Docket No. 50-255

The Commission has issued the enclosed Amendment No. 4.1 to Provisional Operating License No. DPR-20 for the Palisades Plant. This amendment consists of changes to the Technical Specifications in response to your requests dated February 22, 1978, as supplemented by letter dated March 7, 1978.

Amendment No. 41  
License No. DPR-20

ATTACHMENT TO LICENSE AMENDMENT NO. 41  
PROVISIONAL OPERATING LICENSE NO. DPR-20  
DOCKET NO. 50-255

PRESSURE-TEMPERATURE LIMITS  
 FOR HEATUP - TO  $3.0 \times 10^6$  MWDT  
 FIGURE 3-1

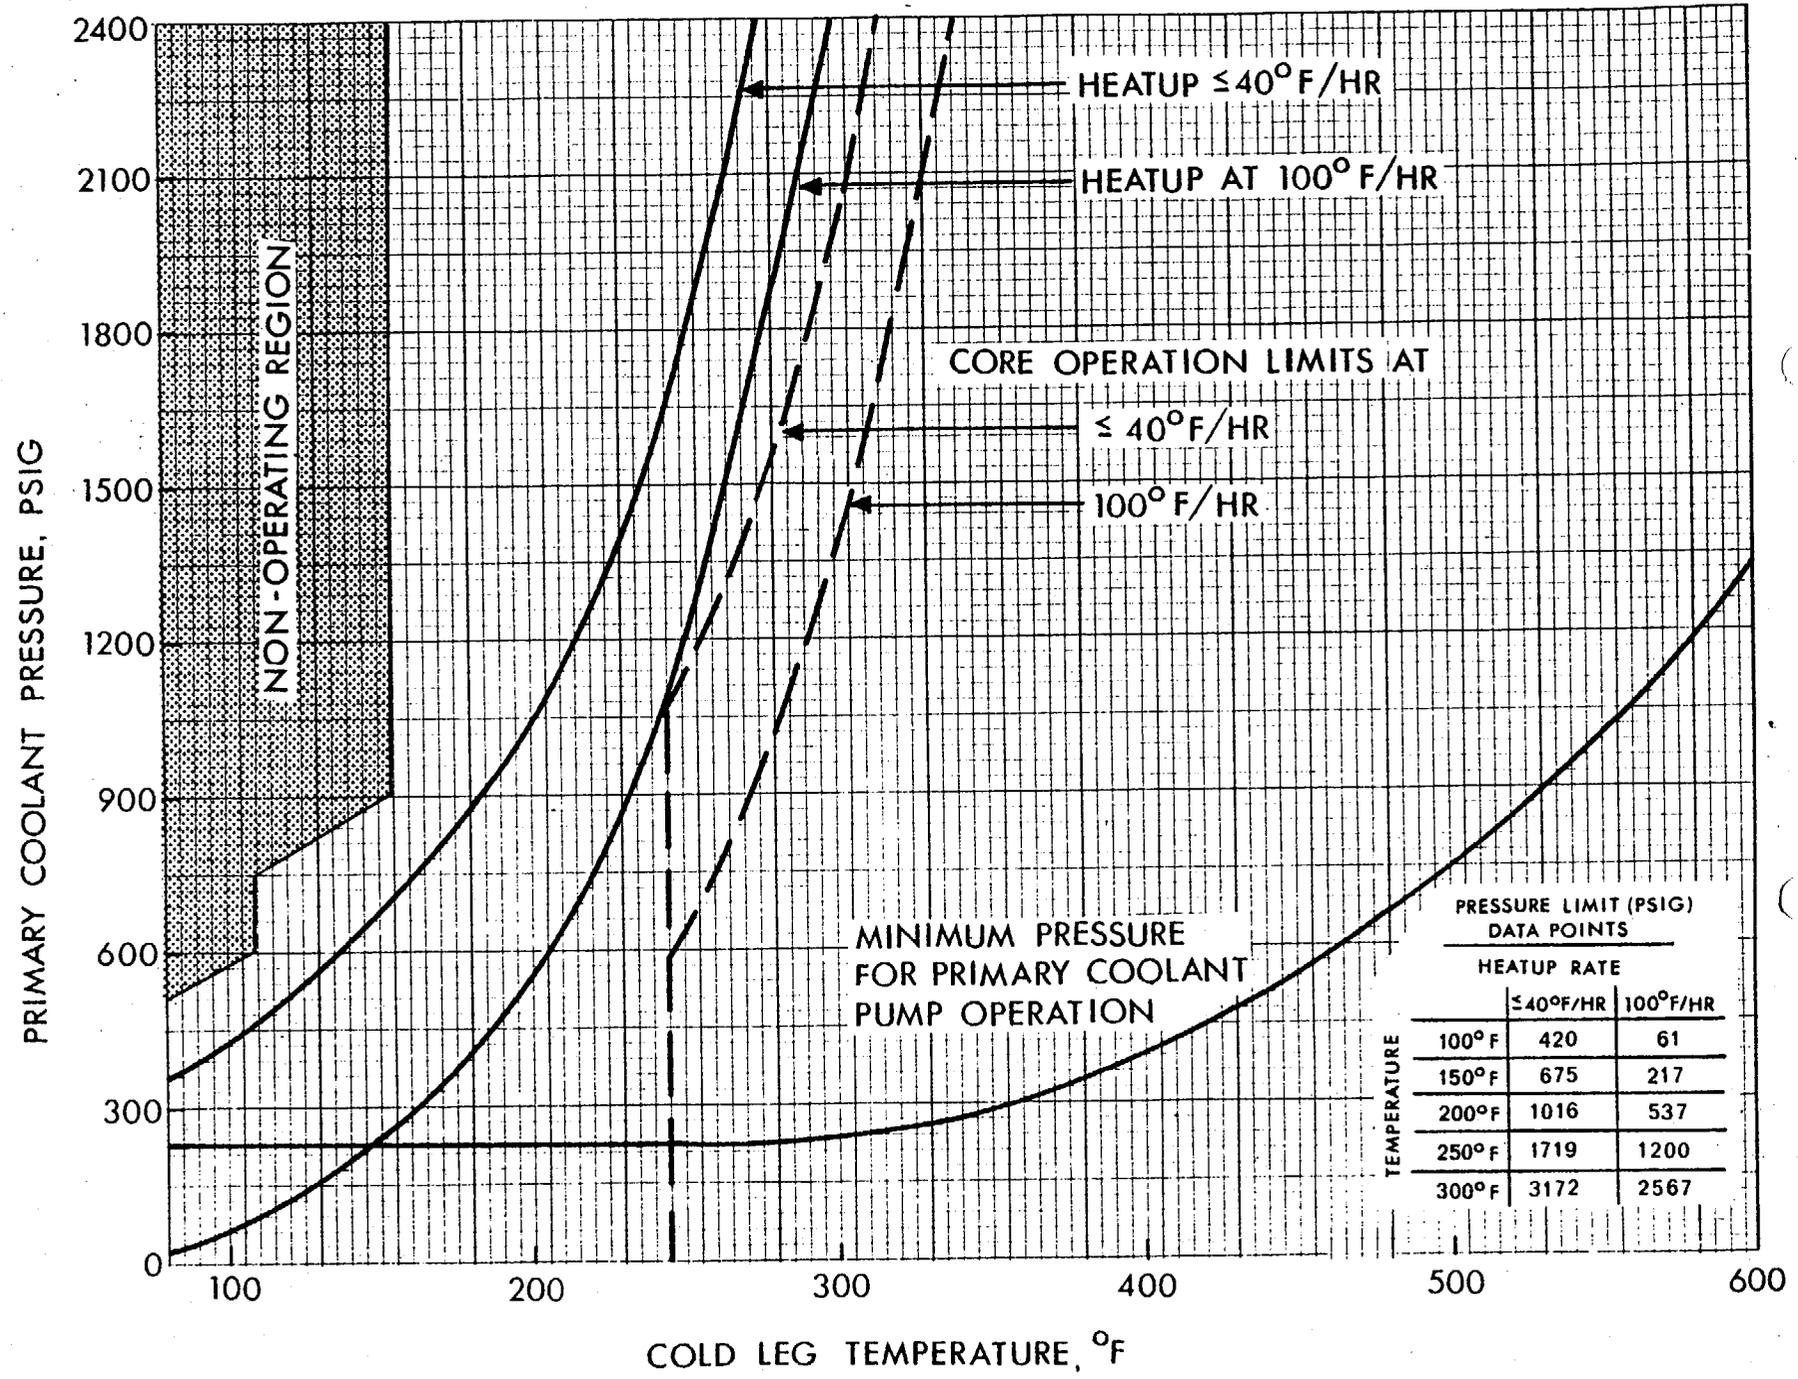
- a. Allowable combinations of pressure and temperature for any heatup rate shall be below and to the right of the limit lines as shown on Figure 3-1. The average heatup rate shall not exceed 100°F/h in any one-hour time period.

In a letter dated January 6, 1977, Consumers Power Company requested a change to Technical Specifications 3.1.2 and 3.1.3 of Palisades regarding pressure-temperature operating limits. The proposed operating limits were calculated for reactor vessel irradiation through  $3 \times 10^6$  Mwd<sub>t</sub>. We approved these operating limits for reactor vessel irradiation through  $2.2 \times 10^6$  Mwd<sub>t</sub>.

The operating period for these pressure-temperature operating limits was reduced because the initial (unirradiated) value of RT<sub>ndt</sub> of the reactor vessel materials was not accurately determined. Since this submittal, Battelle Columbus Laboratories have conducted tensile, Charpy V-notch and drop weight tests on unirradiated base, HAZ and weld specimens to establish baseline data for the Palisades material surveillance program. In letter dated February 22, 1978, Consumers Power Company submitted the results of the above test program and submitted a request to change Technical Specifications 3.1.2 and 3.1.3 for Palisades. The heatup/cooldown curves in the February 22 submittal were modified by Consumers Power Company letter dated March 7, 1978.

The proposed operating limits are proposed for operation through  $3.0 \times 10^6$  MWd<sub>t</sub> which is through the completion of the current cycle, Cycle 3. During Cycle 3, tests will be conducted on the first irradiated capsule removed from Palisades. Thus, for the next operating period, Cycle 4, pressure-temperature operating limits will be based on irradiated test data from the Palisades surveillance program. Since at present no irradiated capsules have been tested, the operating limits through  $3.0 \times 10^6$  MWd<sub>t</sub> are based on data from unirradiated material and radiation damage predictions of Regulatory Guide 1.99, Revision 1. Base material with a copper content of 0.25% is the limiting material for this operating period.

The revised pressure-temperature limits are applicable to reactor vessel inner wall fluences of up to  $3.7 \times 10^{18}$  nvt or approximately  $3.0 \times 10^6$  MWd of thermal reactor power. The application of appropriate fluence attenuation factors at the 1/4 and 3/4 thickness locations results in fluences

We have reviewed the proposed change to Technical Specification 3.1.2 and 3.1.3 and conclude that it is in accordance with Appendix G, 10 CFR Part 50 and is acceptable for operation through  $3.0 \times 10^6$  MWd<sub>t</sub>. Compliance with Appendix G in establishing safe operating limitations will ensure adequate safety margins during operation, testing, maintenance and postulated accident conditions and constitute an acceptable basis for satisfying the requirements of NRC General Design Criterion 31, Appendix A, 10 CFR Part 50.

PRESSURE-TEMPERATURE LIMITS  
FOR COOLDOWN - TO 30X10<sup>6</sup> MW D1

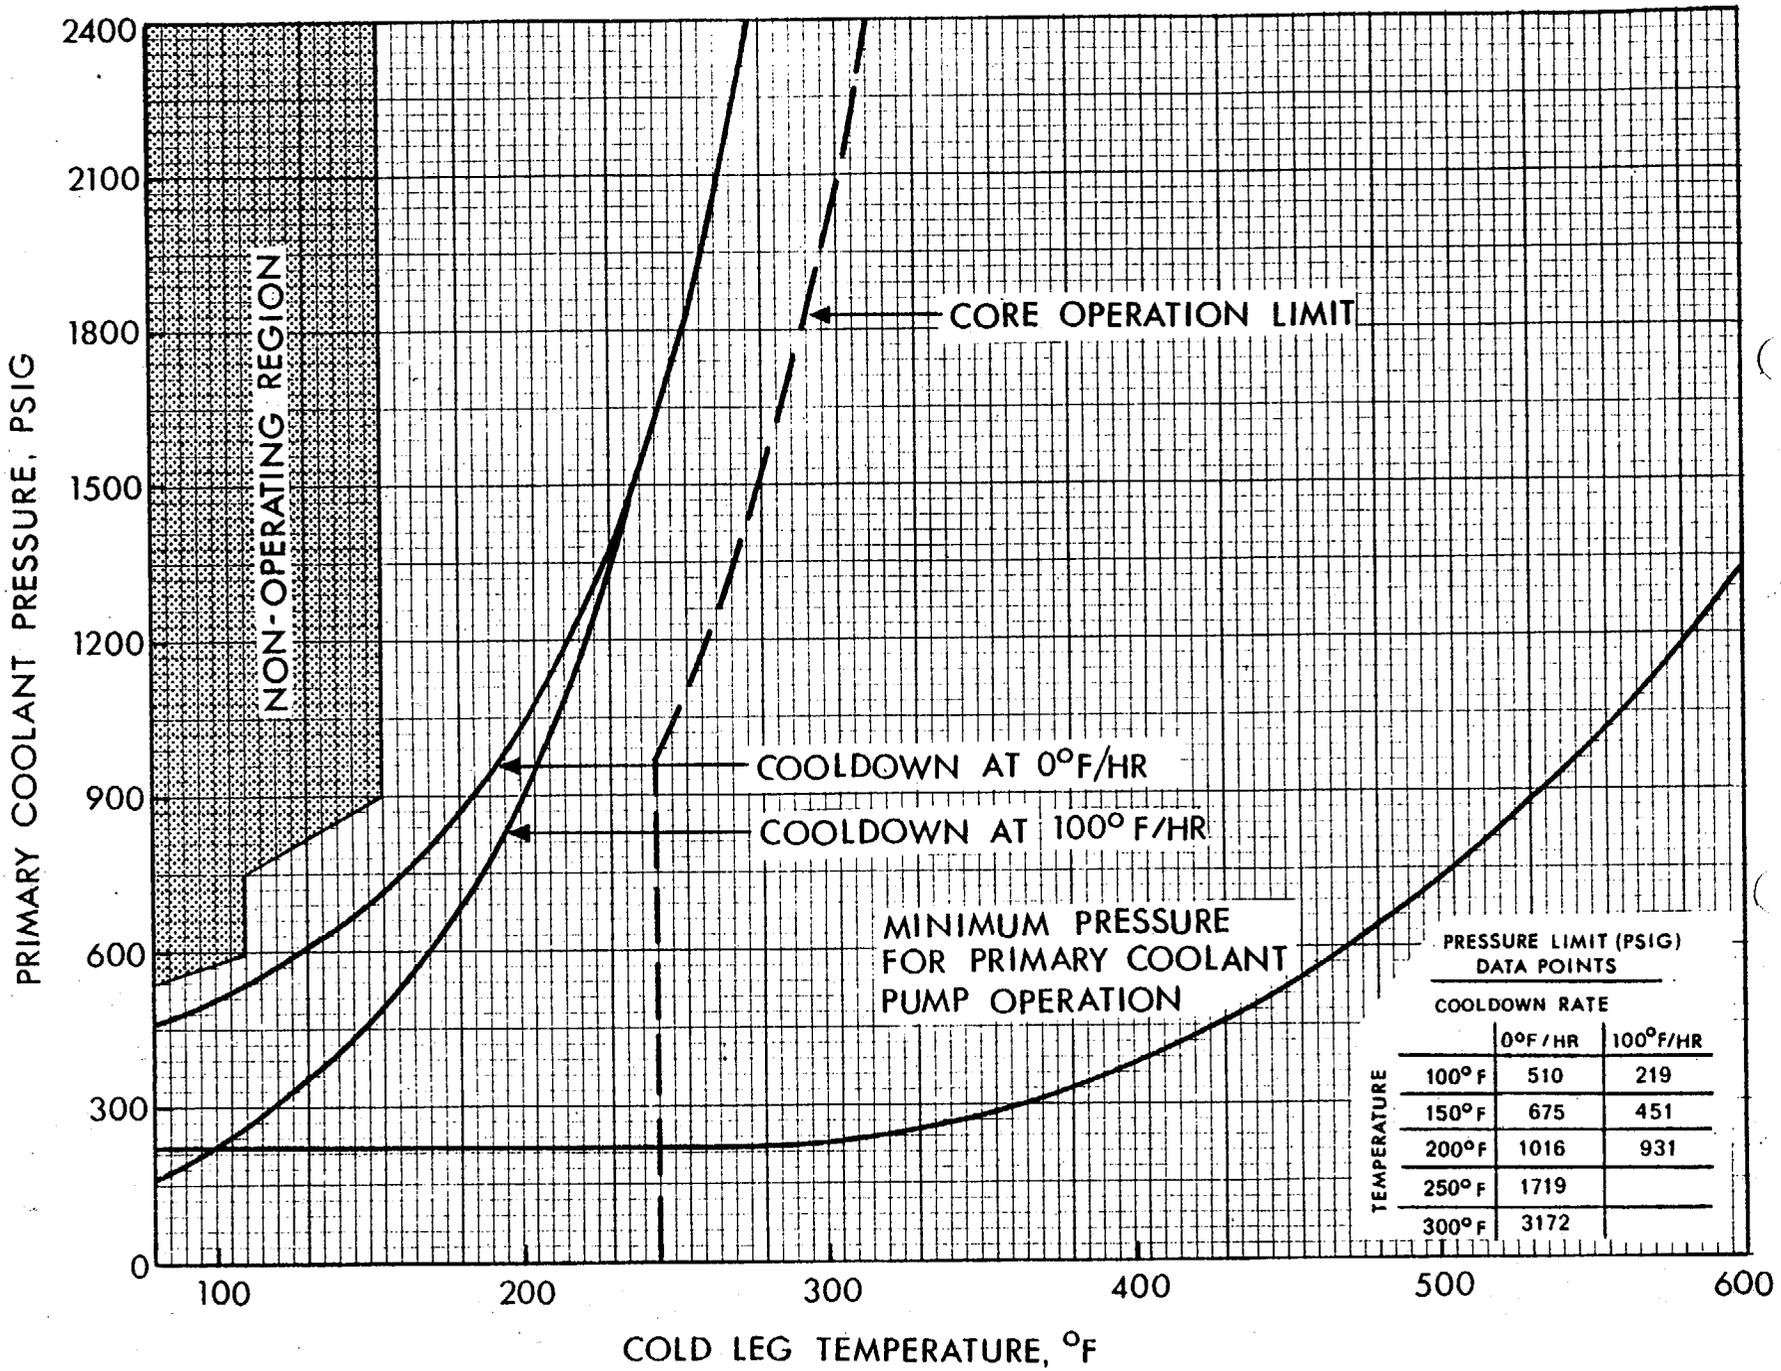
- b. Allowable combinations of pressure and temperature for any cooldown rate shall be below and to the right of the limit lines as shown on Figure 3-2. The average cooldown rate shall not exceed 100°F/h in any one-hour time period.

PRESSURE - TEMPERATURE LIMITS  
INSERVICE TEST - 103.0X10<sup>6</sup> MWDT  
FIGURE 3-3

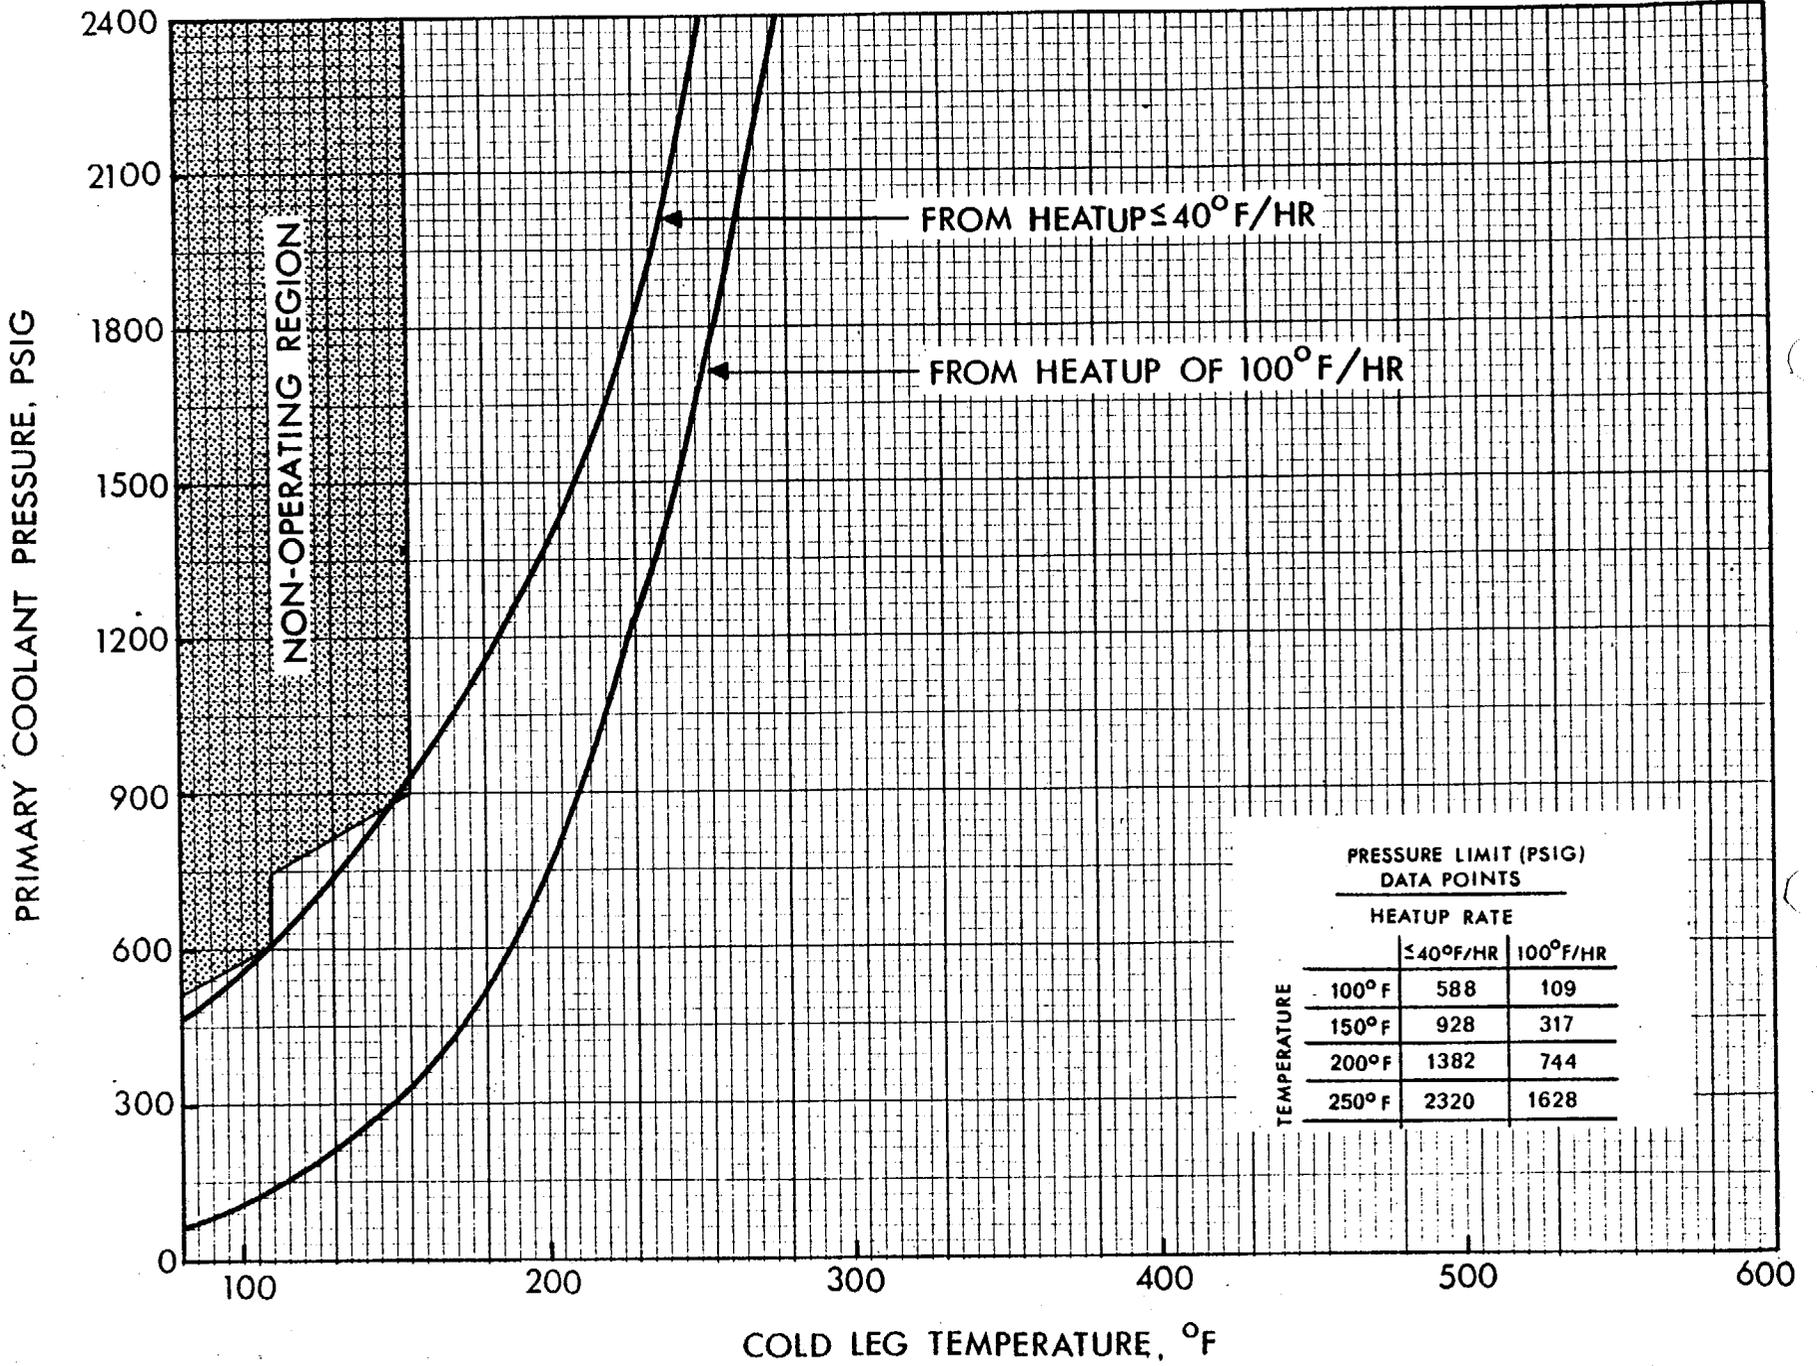
- c. Allowable combinations of pressure and temperature for inservice testing from heatup are as shown in Figure 3-3. Those curves include allowances for the temperature change rates noted above. Interpolation between limit lines for other than the noted temperature change rates is permitted in 3.1.2a, b or c.

The criticality temperature is determined per Reference 8 and the core operational curves adhere to the requirements of Reference 9. The inservice test curves incorporate allowances for the thermal gradients associated with the heatup curve used to attain inservice test pressure. These curves differ from heatup curves only with respect to margin for primary membrane stress.<sup>(7)</sup> For heatup rates less than  $60^{\circ}\text{F}/\text{h}$ , the hypothetical  $0^{\circ}\text{F}/\text{h}$  (isothermal heatup) at the 1/4 T location is controlling and heatup curves converge. Cooldown curves cross for various cooldown rates, thus a composite curve is drawn. Due to the shifts in  $RT_{NDT}$ , NDTT requirements associated with nonreactor vessel materials are, for all practical purposes, no longer limiting.
